Access Compliance Report

Public Rights-of-Way

(Curb Ramps)

Intersection ID: 2480	Main Street: CAMBRIDGE_BAY_DR	Cross Street: HEARST_CT	Location: SW
ADA ID: F14DDC321AF5	Ramp Type: PerpDiag	Initial Pass/Fail: Pass	Overall Compliance: No
Codes/Mitigation Info/Possible Solution		Field Measurements/Component Compliance	
Severity Score: 21.75

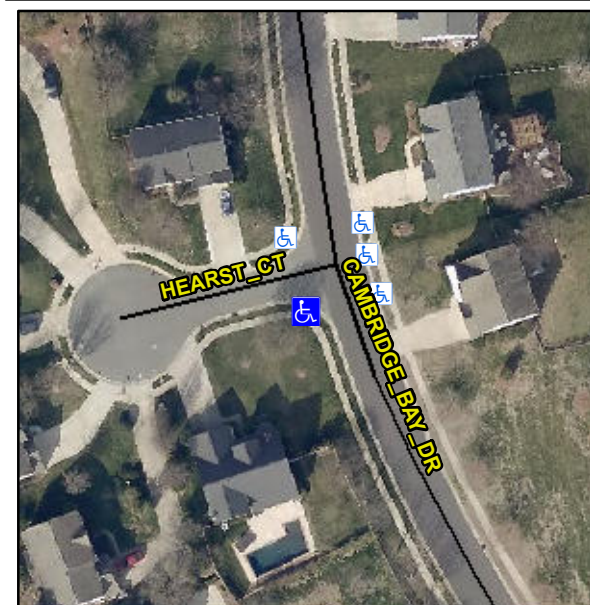
Remove & Replace Curb Ramp With Two New Directional Ramps or Equivalent. Grind Gutter Lip.

R304.5.3, R304.2.1, R305, R302.7.2
